Model: SP5/SP5L LCT		Date: 15-Mar-99	No.: MA698001
Modified Article: Relay Connector for the Main Frame		Prepared by: A. Sasaki	
From: Technical Service Dept., GTS Division			
Reason for Modification:	<input checked="" type="checkbox"/> Parts catalog correction <input type="checkbox"/> To facilitate assembly <input type="checkbox"/> Part standardization	<input type="checkbox"/> Vendor change <input type="checkbox"/> To improve reliability <input type="checkbox"/> Other	<input type="checkbox"/> To meet standards ()

5. Electrical Section (A698)

Model: SP5/SP5L/Mojito LCT	Date: 15-Jul-99	No.: MA698002a
----------------------------	-----------------	----------------

A292/293: Upper position
A229: Lower position (factory setting)

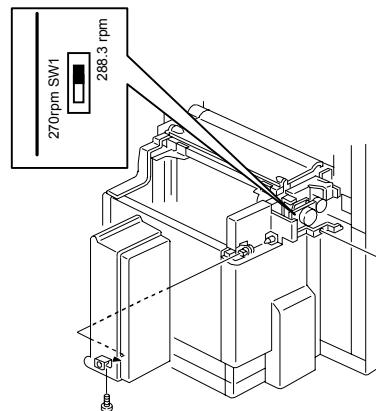
To allow this LCT (RT37) to be installed on a new model (Mojito A292/A293), the motor has been changed because the A292/A293 model has a faster process speed.

The new motor can be used on both models, A229 and A292/A293, but the DIP switch has to be changed to the upper position (288.3 rpm) as shown when the RT37 is installed on the A292/A293. The factory setting is the lower position.
